As-Built Baseline Monitoring Report

Little Pine Creek II

Monitoring Year 0

Subject: Draft Baseline Monitoring Report (MYO)
Little Pine Creek II Mitigation Project, Alleghany County
DMS Project # 856
DEQ Contract #LP082819

Integrated CCPV
Little Pine Creek II
Alleghany County, NC

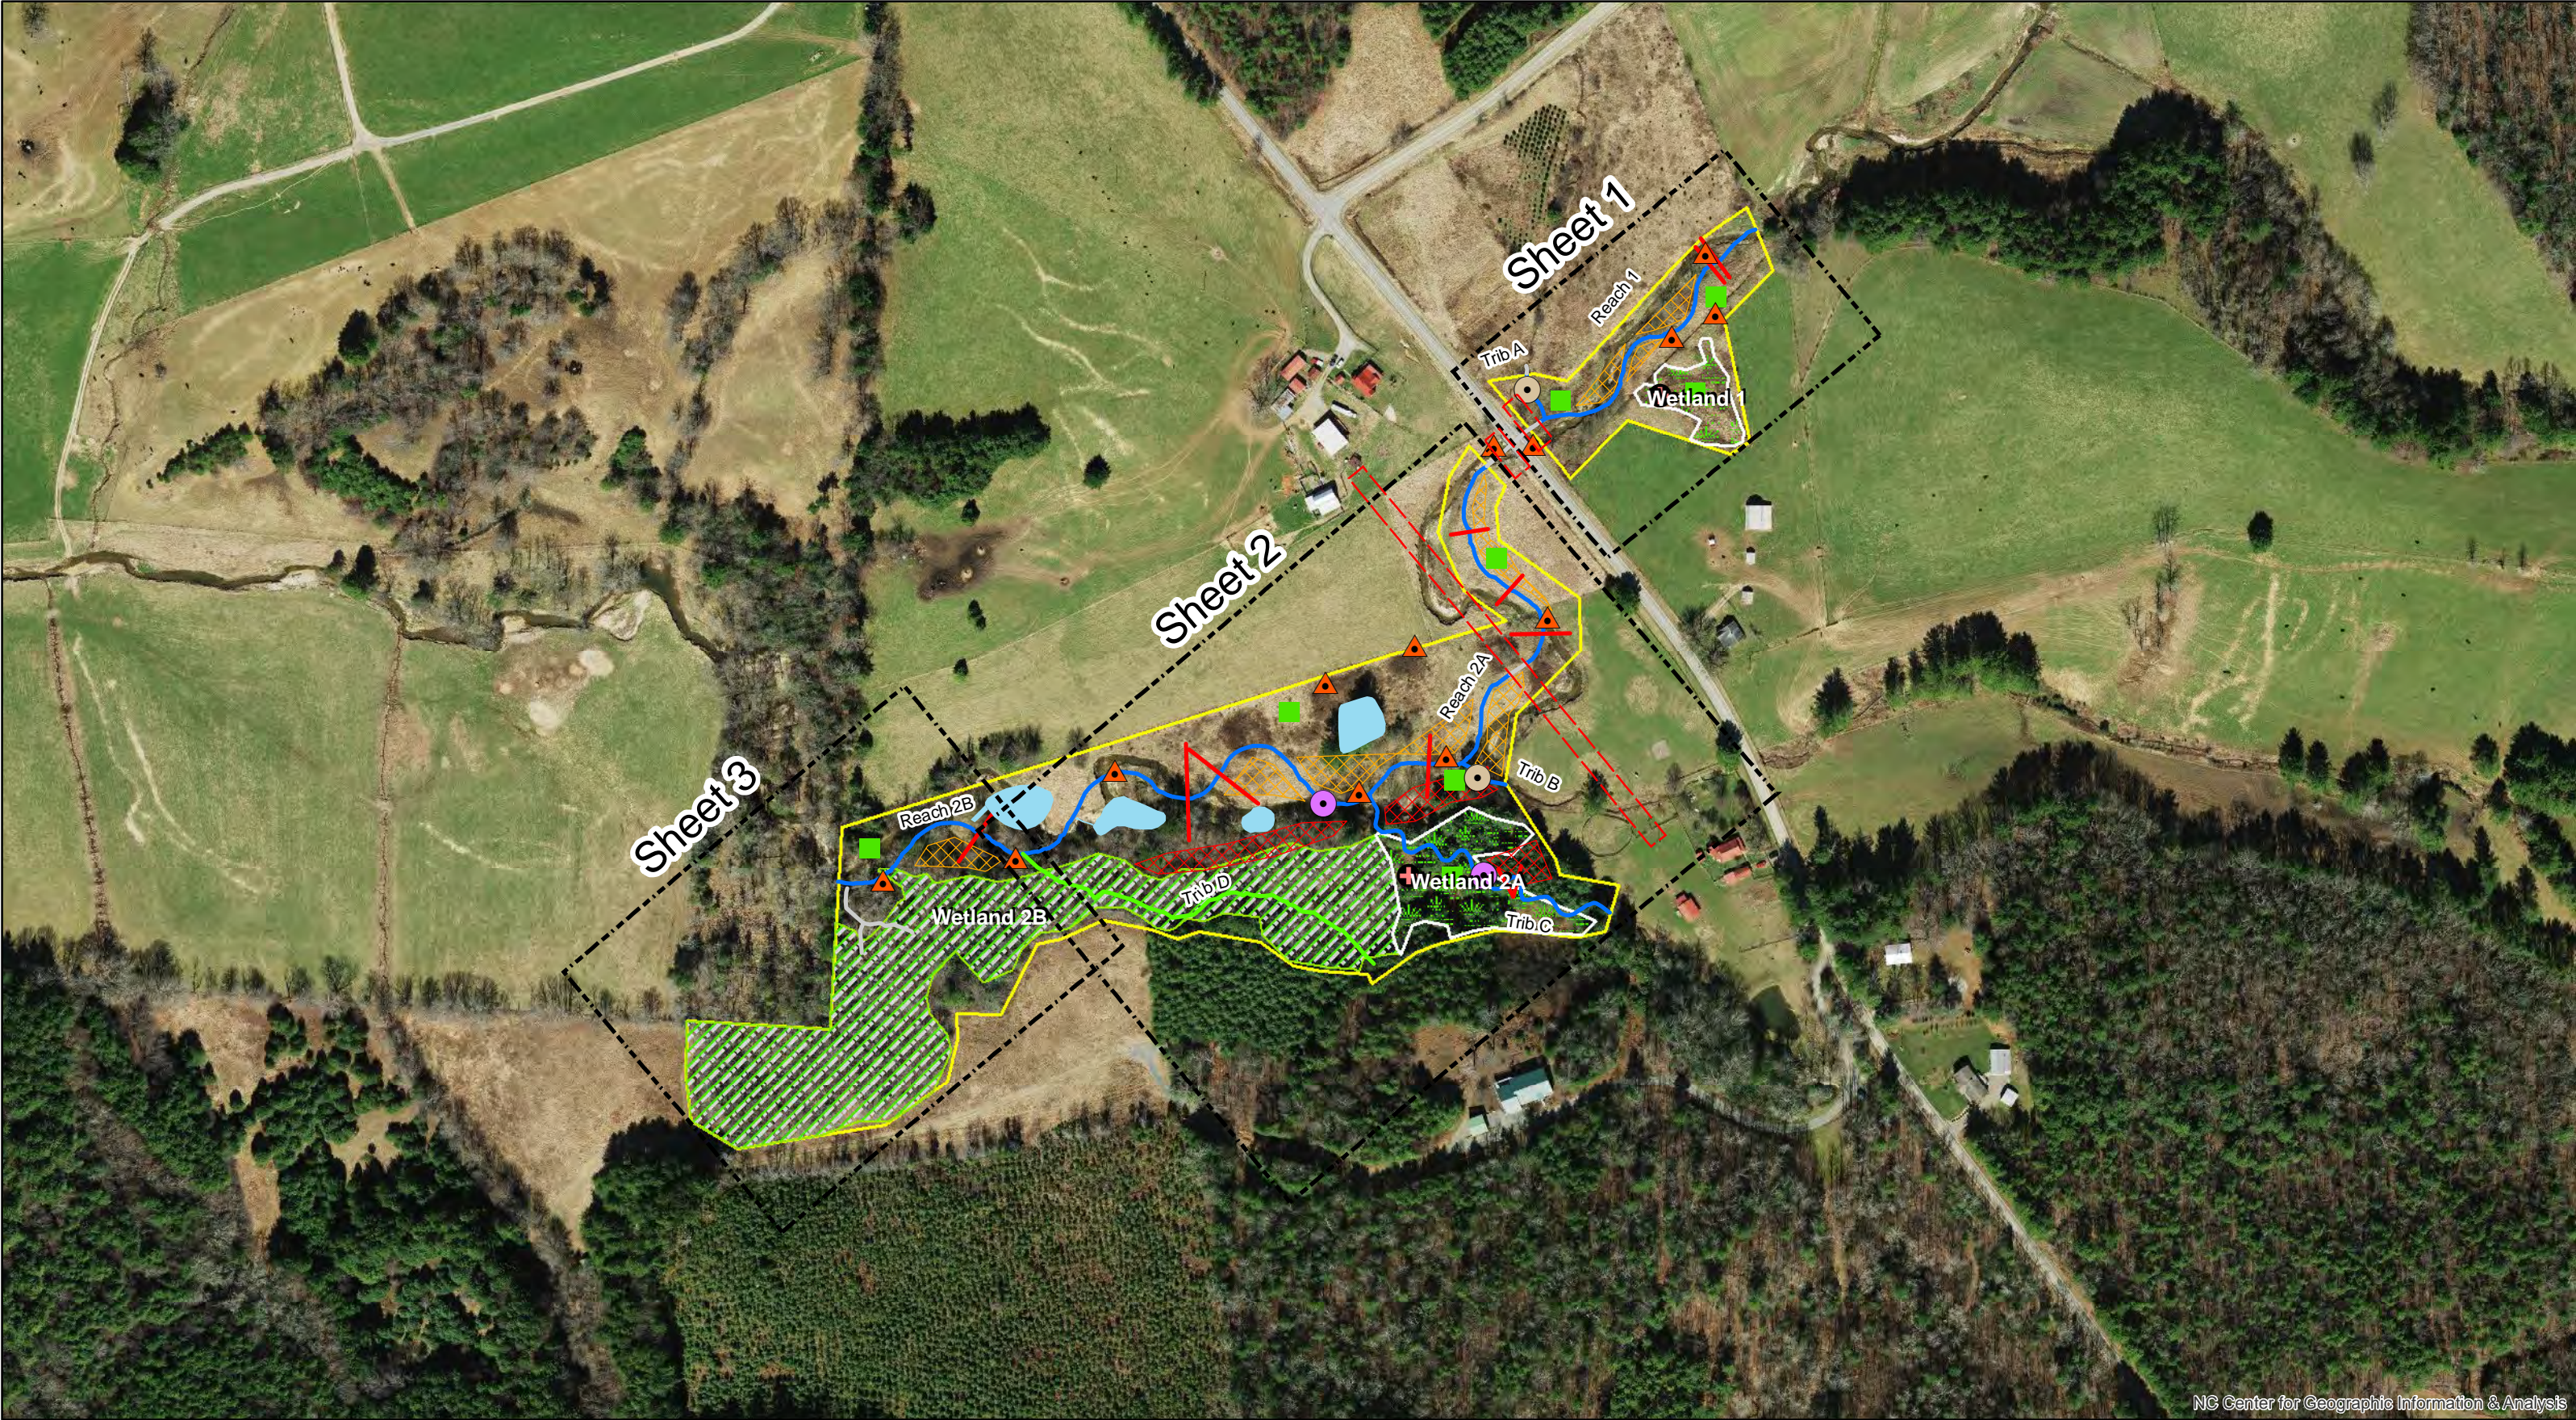
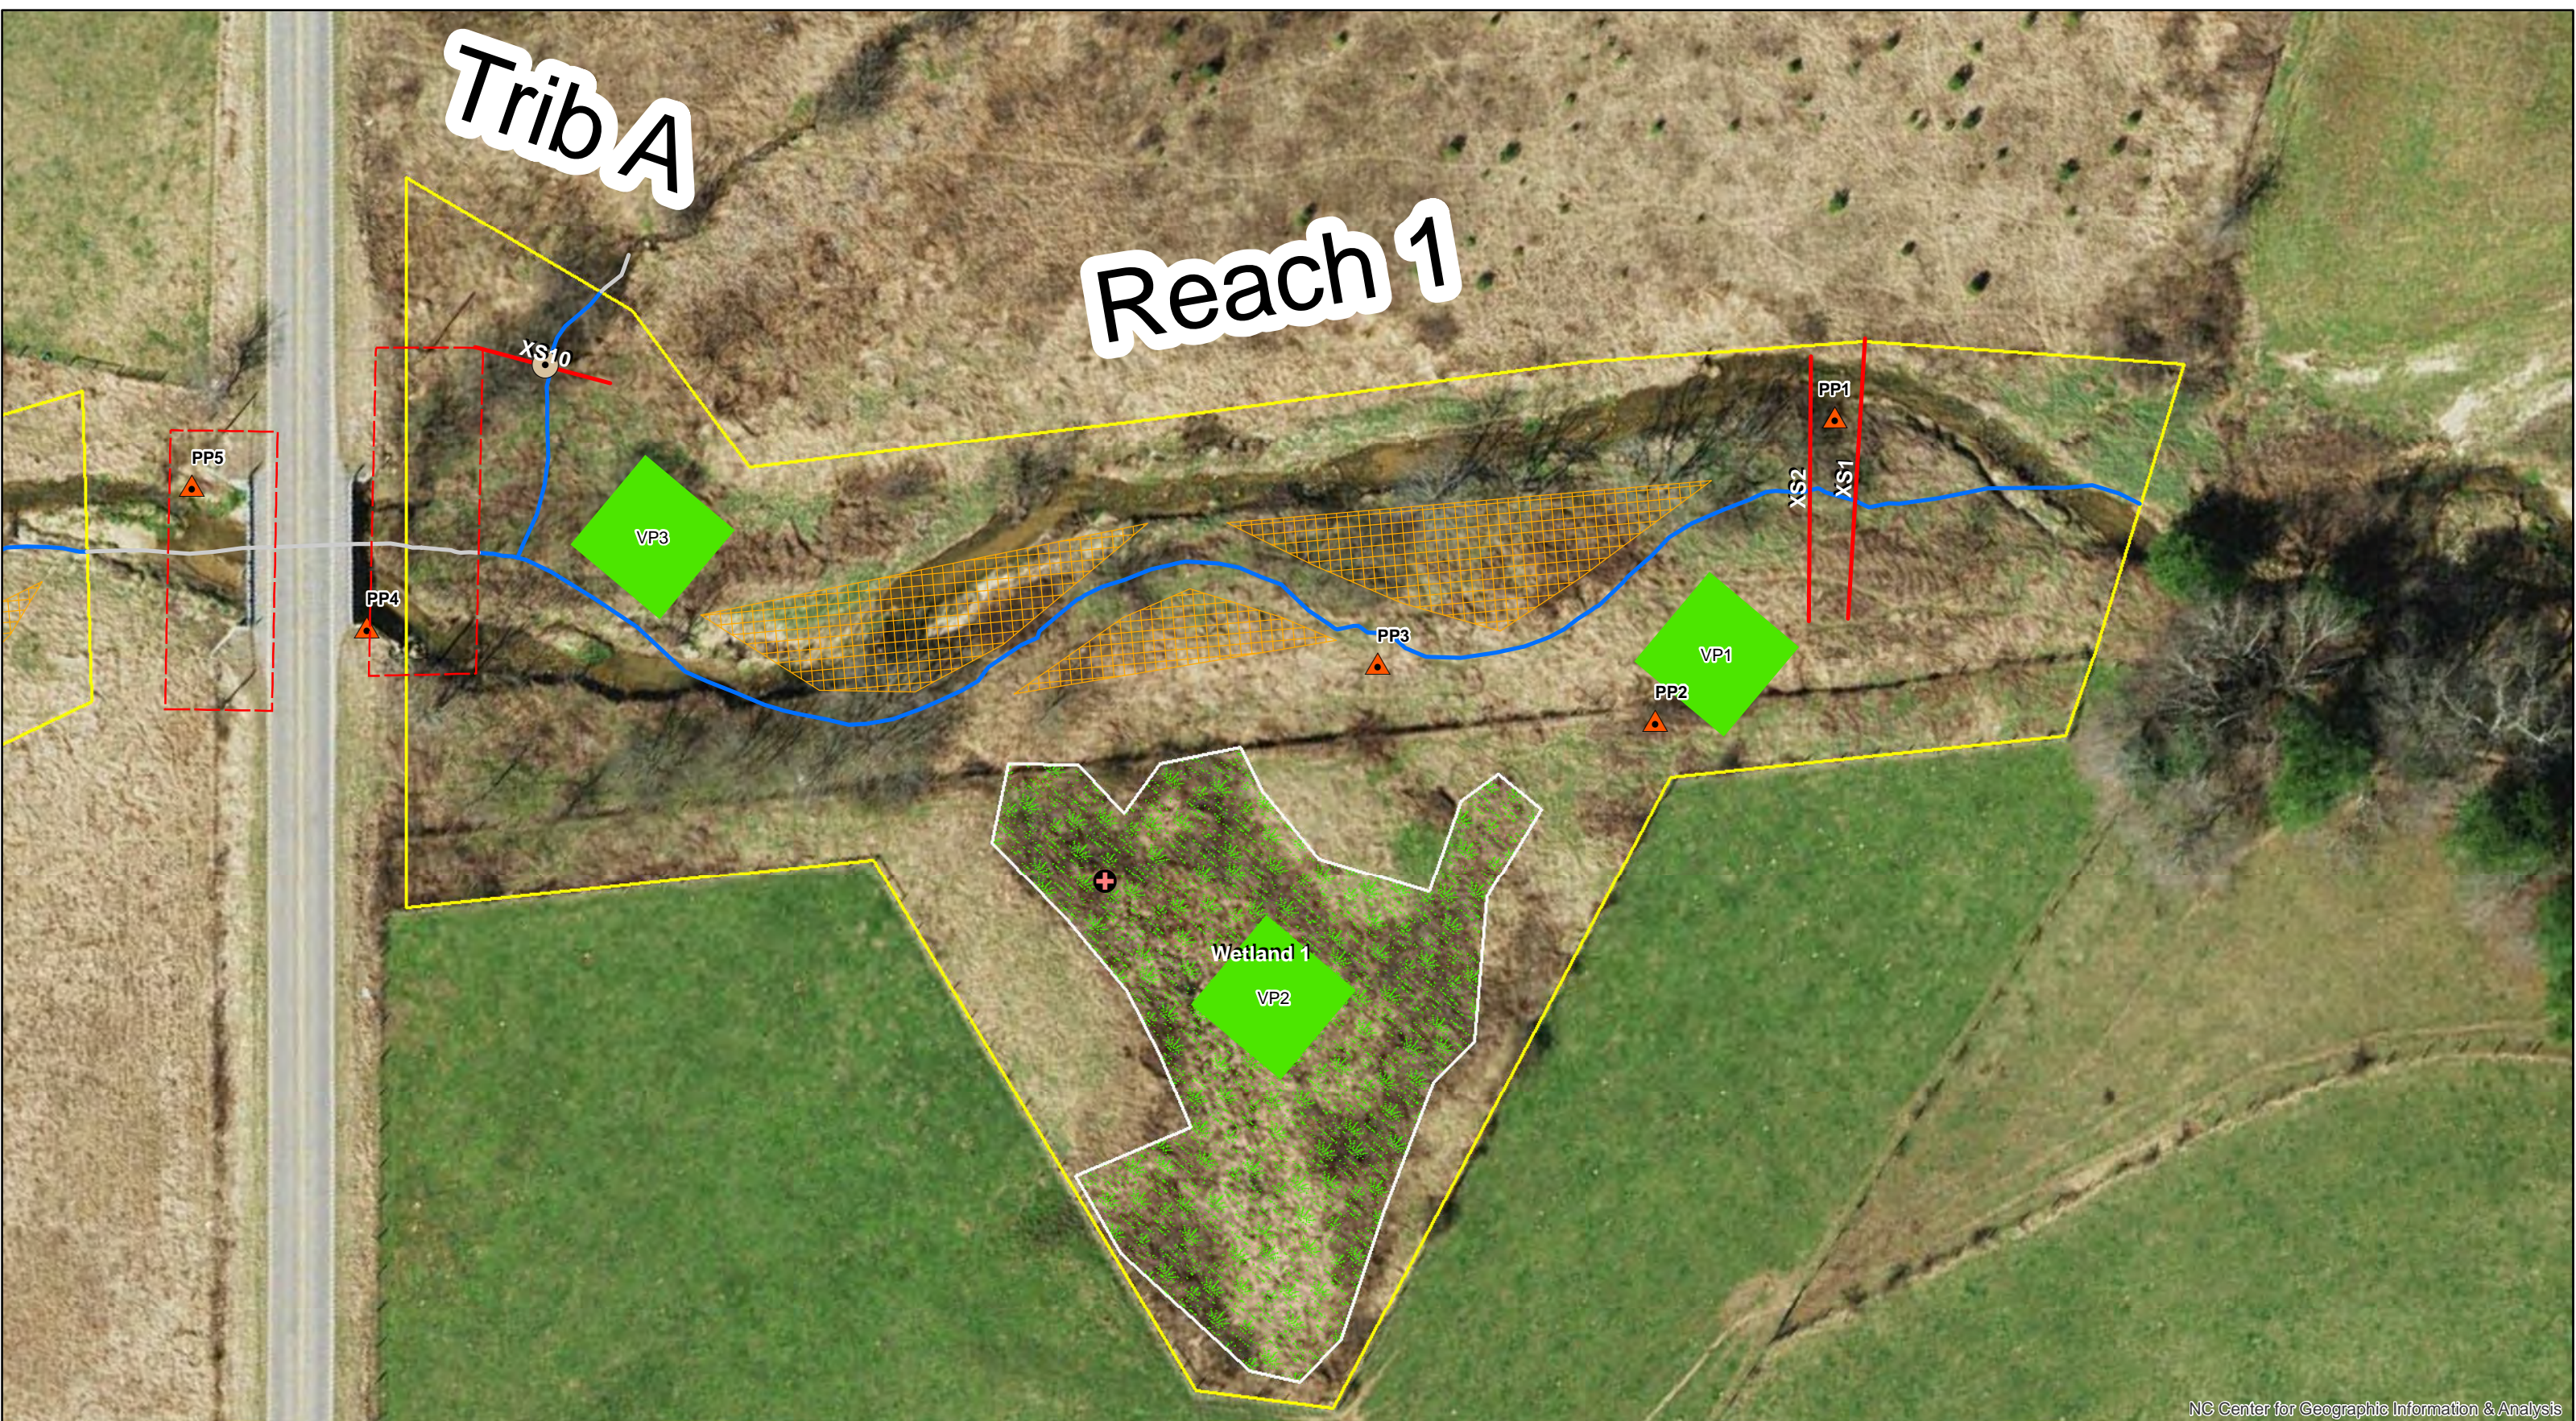
- *Maps – CCPV, Assets/Components, and Monitoring features should all be combined, and split into 3 detail maps (Generally, LPC Reach 1, Reach 2A, and Reach 2B and surrounding areas). These are typically called “Integrated CCPV” Sheet 1, 2, etc. Zooming in will allow all features to be included on each sheet, enable a better resolution, and avoid redundancy. An overall CCPV sheet with the 3 sheets keyed out with an overlay would work well, so as follows:*

- *Little Pine Creek II Stream and Wetland Mitigation Site (Key).*
 - *Little Pine Creek II Integrated Current Condition Plan View (Sheet 1)*
 - *Little Pine Creek II Integrated Current Condition Plan View (Sheet 2)*

- *Little Pine Creek II Integrated Current Condition Plan View (Sheet 3)*CCPV, Assets/Components, and Monitoring features combined on reach scale detail maps.

- *Constructed vernal pools should be added to the CCPVs.*
Constructed vernal pools were added to the CCPVs.
- *CVS table – At construction close out, the designer certified that the site was planted at 605 stems per acre (4665 bare roots / 7.7 acres), per the construction contract (bid addendum 03, dated 9/28/2017); the site wide stem density (273 stems/acre) indicates high mortality or below the planting density requirement. Did Equinox find that the plots had planted stems that died, or just were not present in the specified planted density? Equinox notes (Sec 4.2.1) that field conditions during the assessments were made in conditions not favorable for identifying planted stems. What field conditions? Can Equinox advise on why the MYO numbers might be below success criteria?*
Equinox did not identify dead stems in the plots; stems were not present. Snow cover of approximately 3-4” and recent alluvial deposition were the field conditions which were unfavorable for assessment. Stems could have been covered by alluvial deposition or removed by high flows.
